**Seismic Walkdown Checklist (SWC)**

Equipment ID No. Q1R43T503 Equip. Class<sup>1</sup> 21

Equipment Description DIESEL GENERATOR 1B STARTING AIR RECIEVER TANK

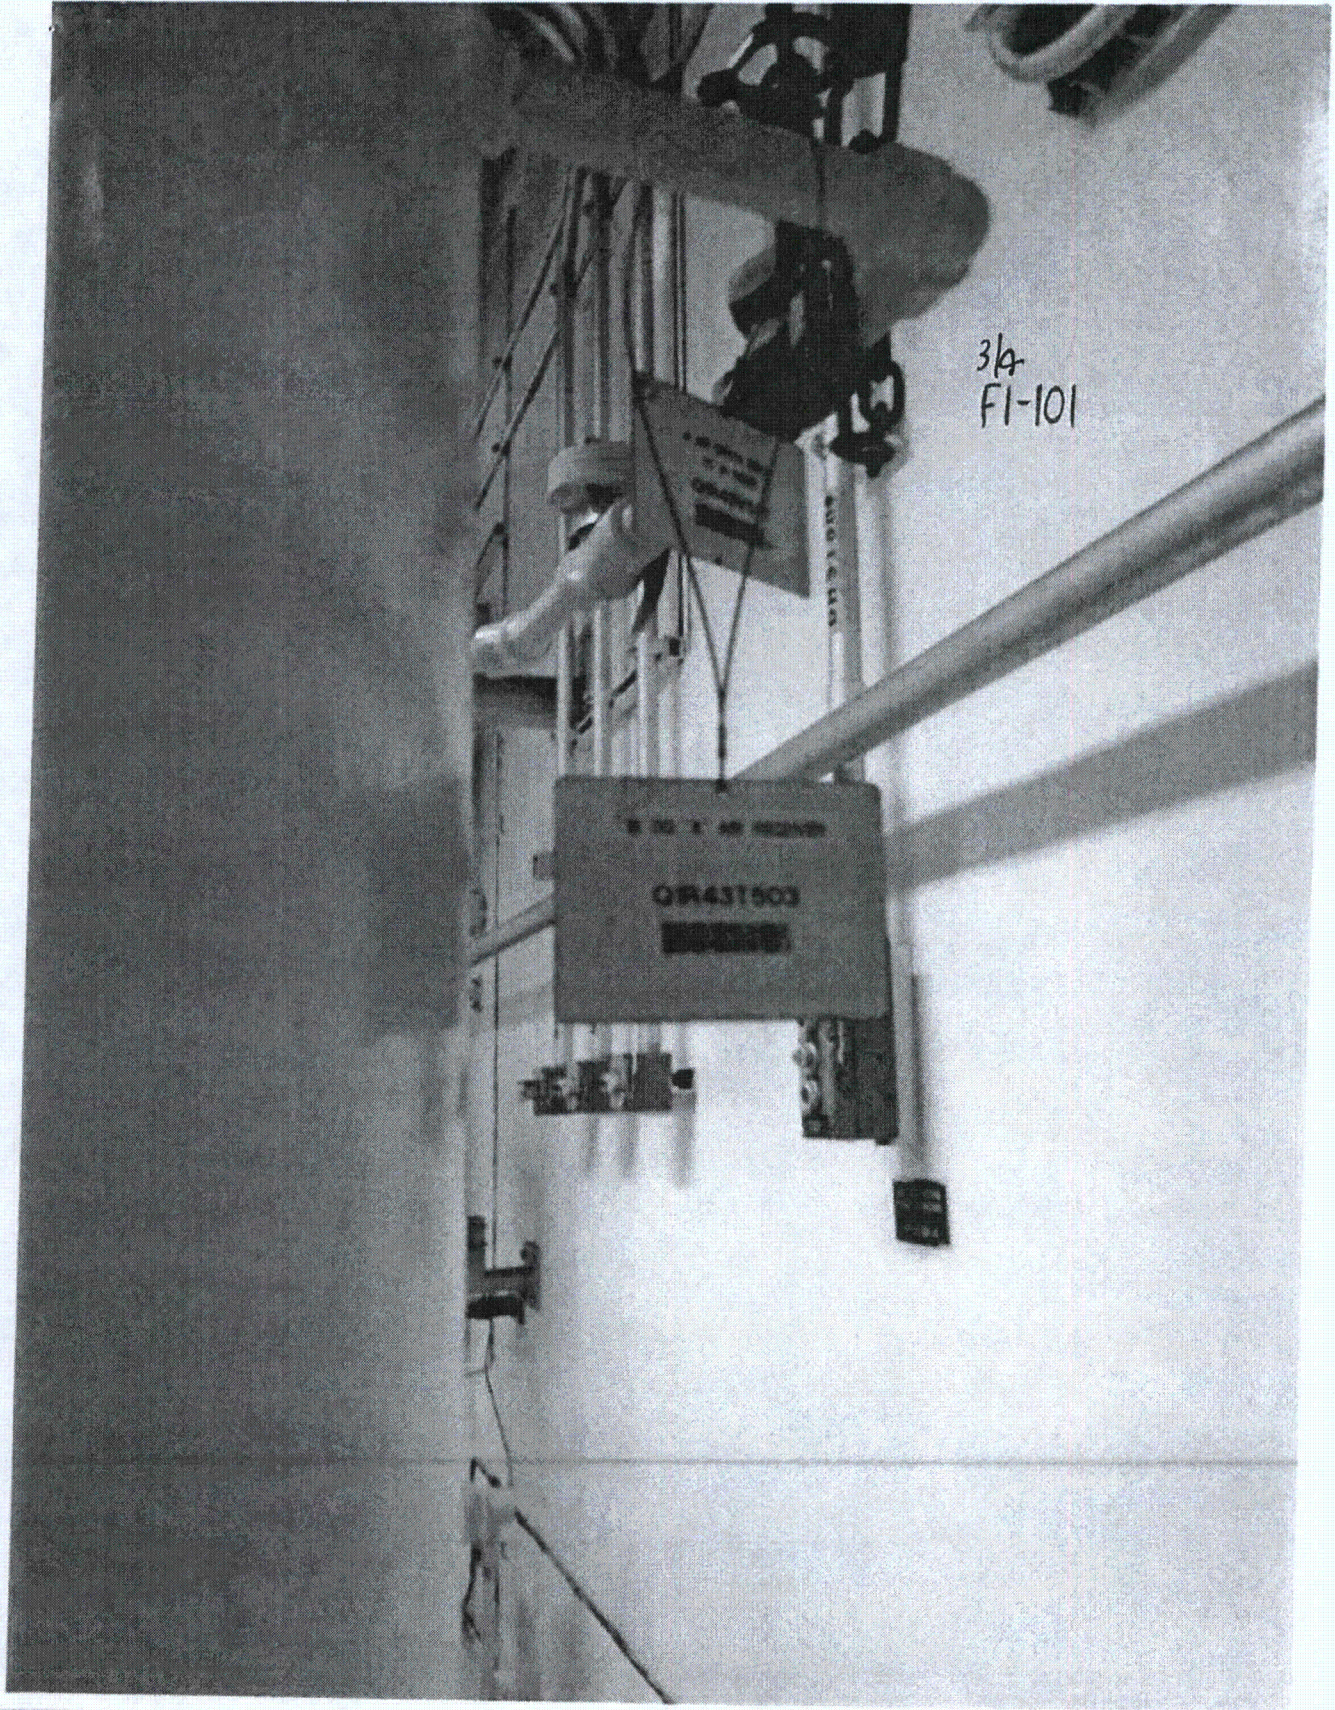
- 7. Are soft targets free from impact by nearby equipment or structures? Y  N  U  N/A   
*Small gap was noted between tank and cantilevered unistrut. This was previously noted in A-46 walkdowns and determined to be acceptable.*

Area walkby for room 5B is with equipment Q1H21E527.

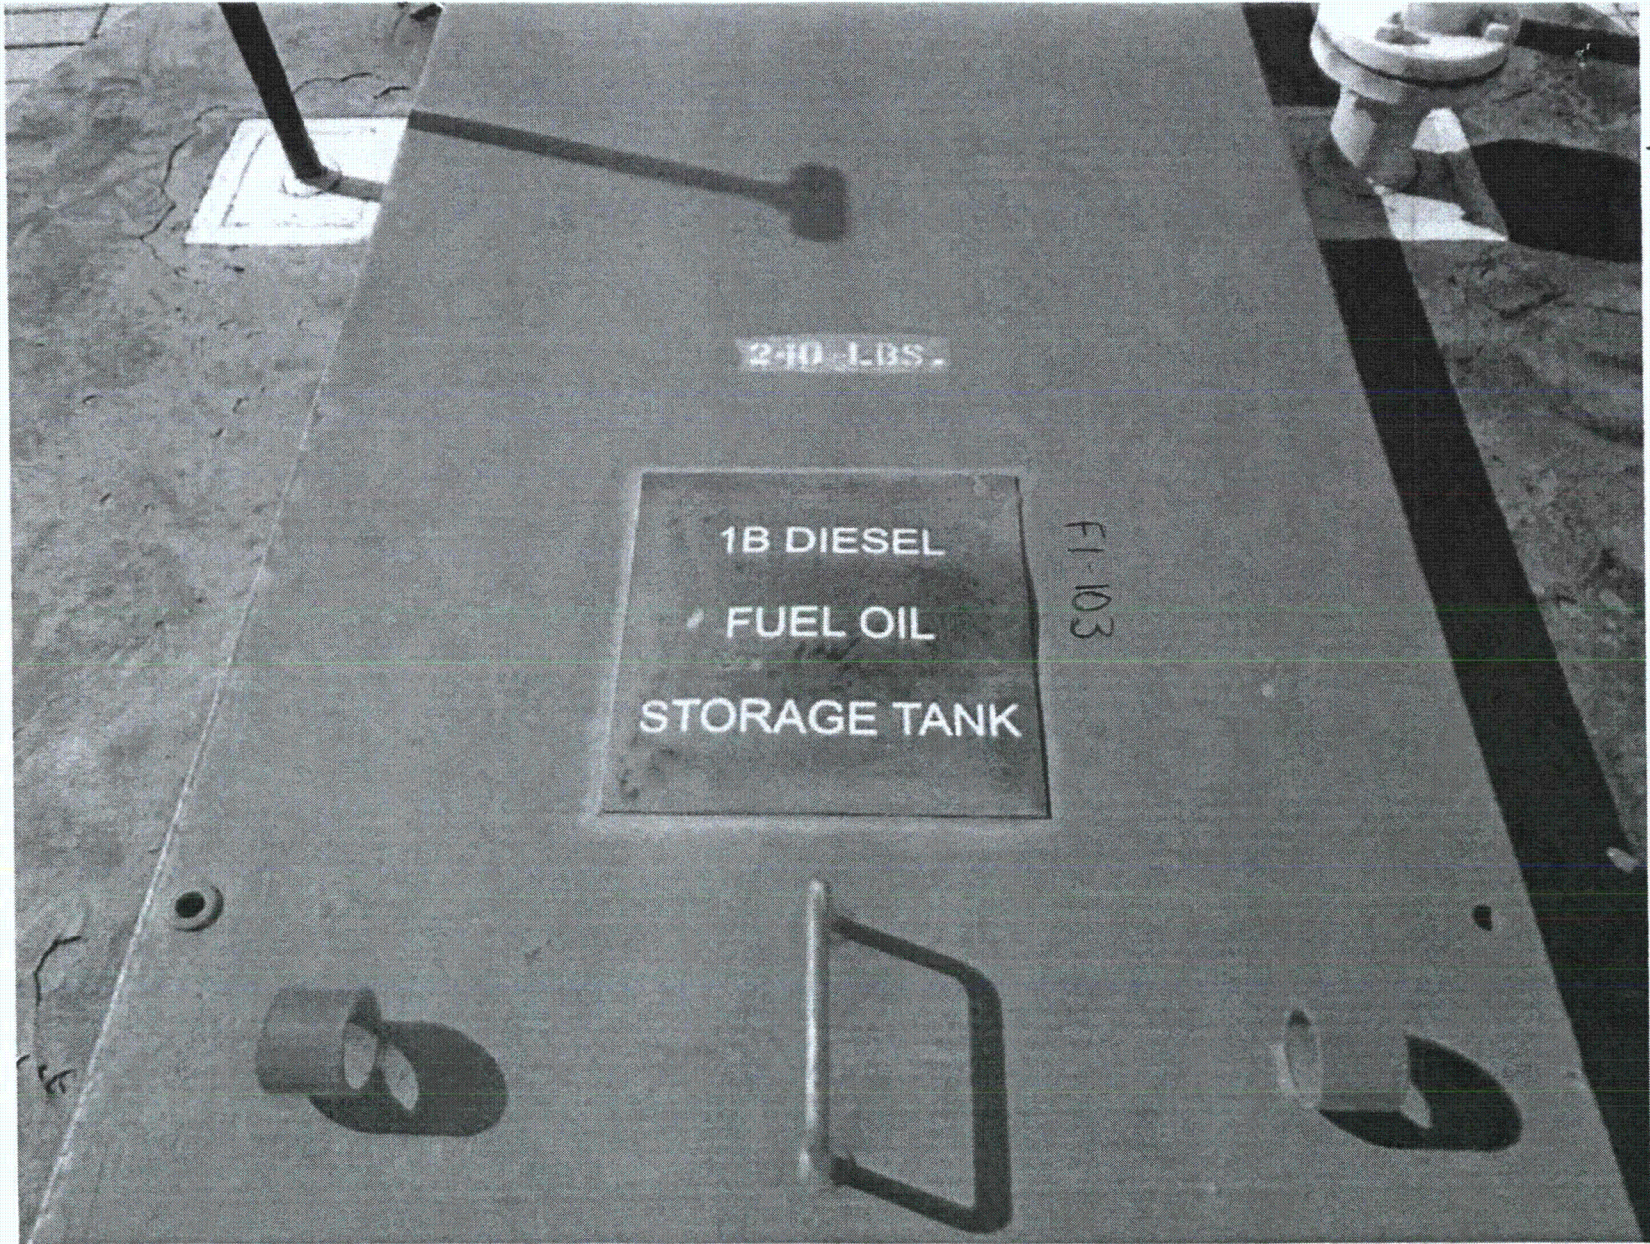
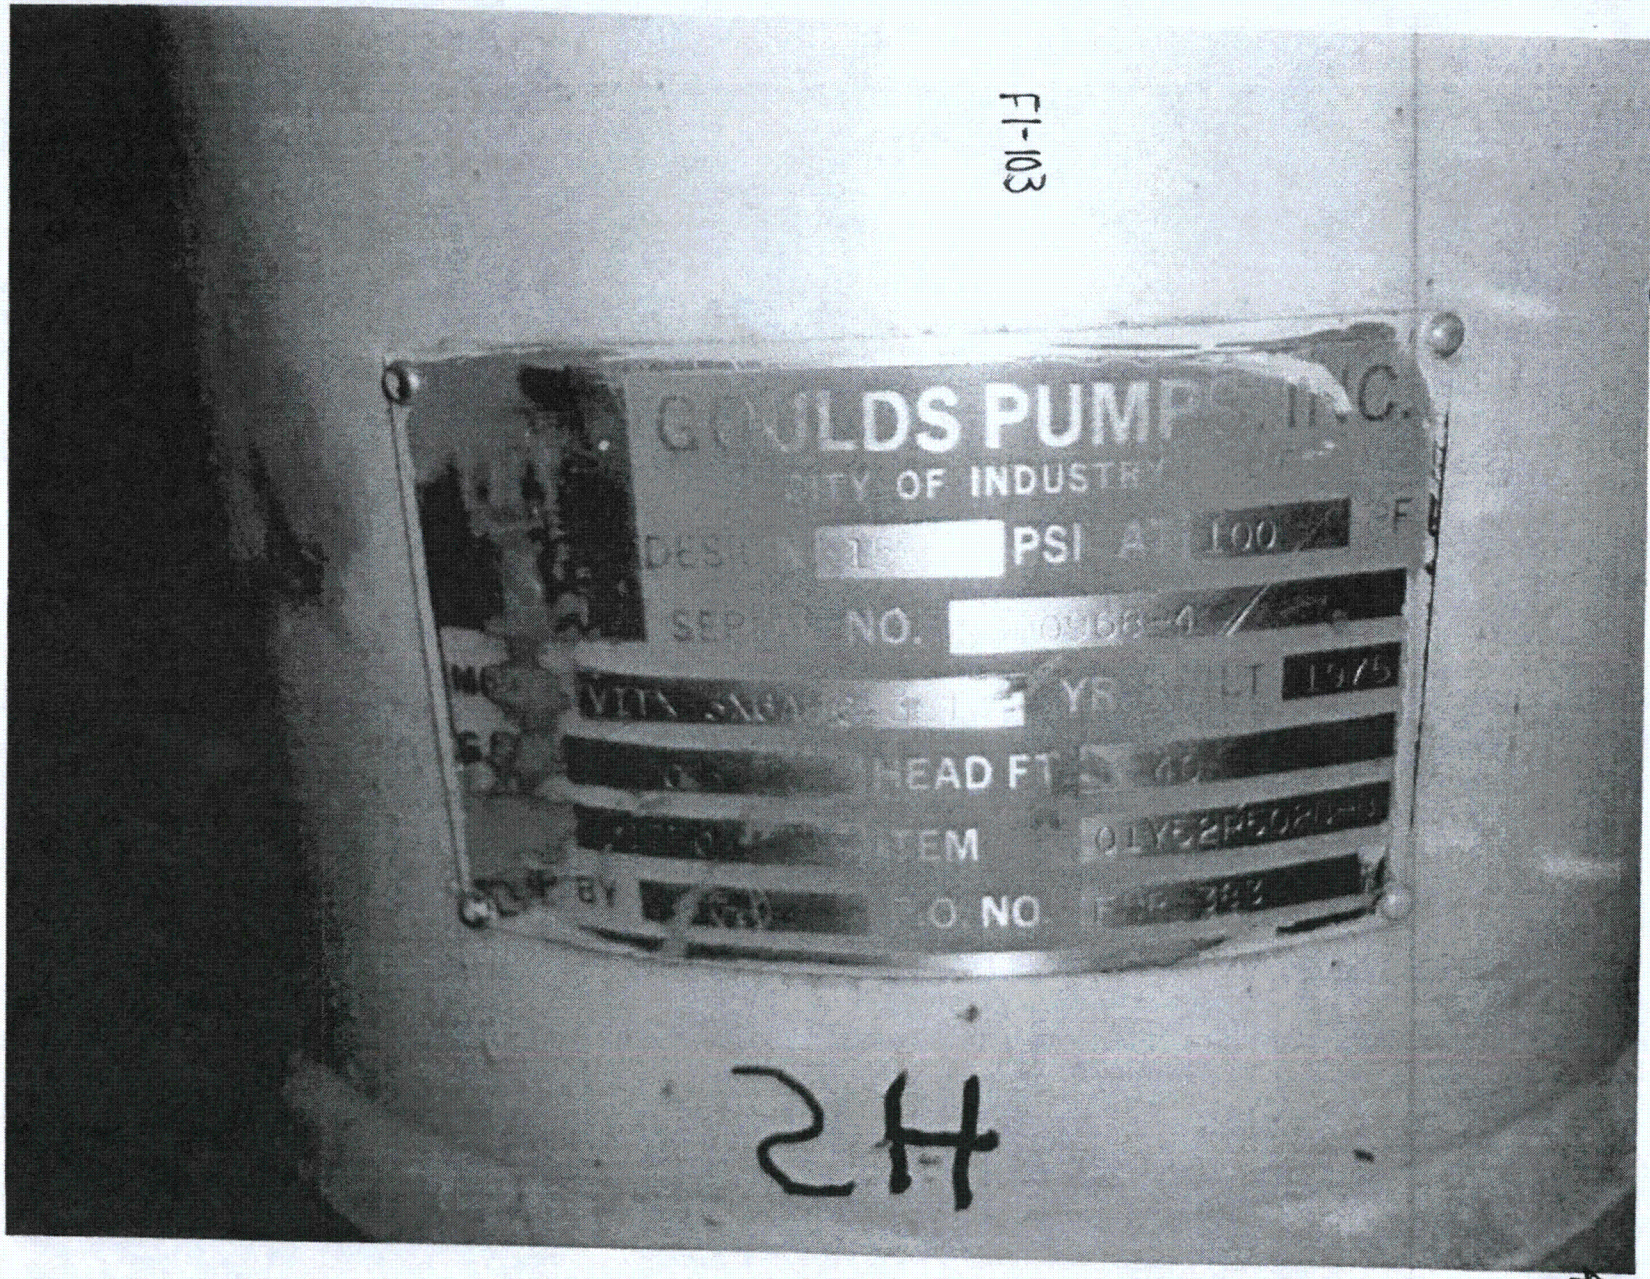
Mass added to pump to attenuate vibrations per MDC S484537901 and the effect on the pump/motor is evaluated for in S484537901C405.
